MEETS LOAD CASE 1 AND SOME OTHER SAFETY REQUIREMENTS CALCULATED BY HAO, IS AN INCOMPLETE REPORT AND FAILS MOST LOAD CASES

HiWind 2024 Structural Analysis

4/30/2024

Trapeze 4gA Case

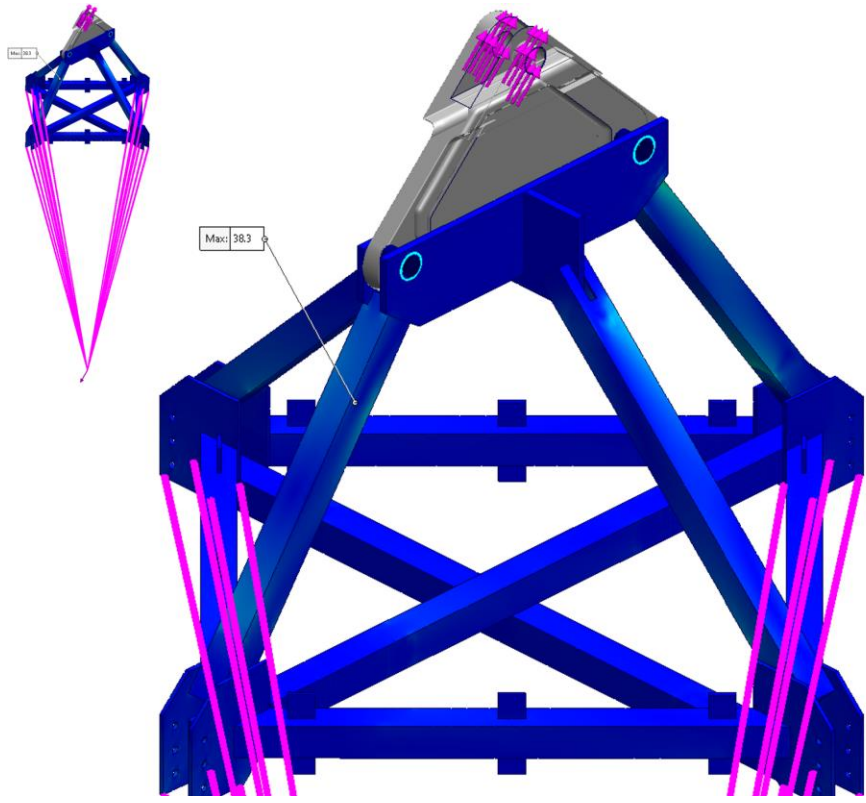
- 4G @ 45° (A)
- Force = 16,800lbf
 - 4,200lbs below trapeze
 - Inertial Relief
 - Equal force distribution at bottom of trapeze
 - Tri-Plate Rigid
 - Remote Load @ CG
- Margins
- $\sigma_{max} = 38.3$ ksi
 - $M_{sy} = 0.32$
 - $M_{su} = 0.81$
